# **Completing the Missing Link *Safely*:**

## **The Ballard Cycle Track Solution**

### **A Safety White Paper**

SDOT's Rendering of the Missing Link On Shilshole Avenue NW

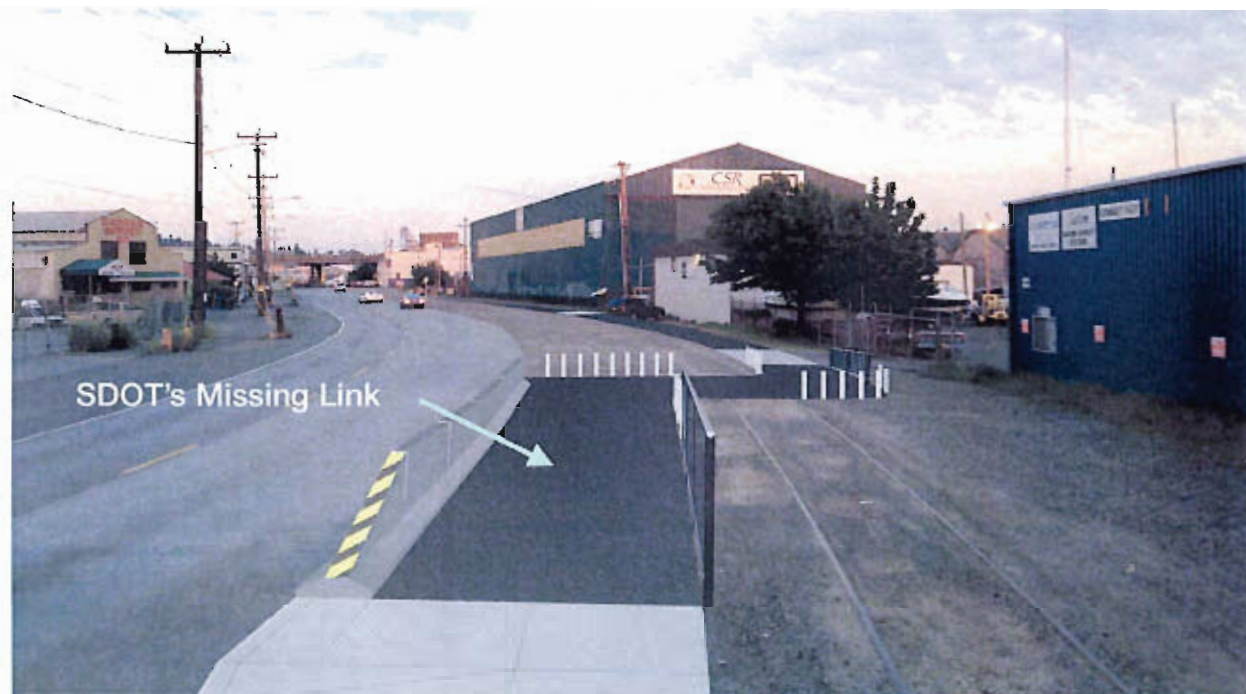
SDOT's design provides no barrier or fence separating cyclists and pedestrians from trucks and cars traveling at 25 to 30 MPH on a Major Truck Street that carries approximately 14,000 vehicle trips per day. People using this trail would be separated only by a 2 ½ inch curb, without sufficient "shy" or safe distance between riders and fast moving vehicles. SDOT's Right-of-

Way Manual requires a minimum shy distance of 3' from the travelled portion of a street and a minimum shy distance of 2' feet from the traveled portion of a path. SDOT's Conceptual Trail Layout below shows only 1' of shy distance between the jersey barrier and travelled portion of Shilshole Avenue NW and 0' feet of shy distance between the trail and the jersey barrier on one side of the trail and the fence on the other side.
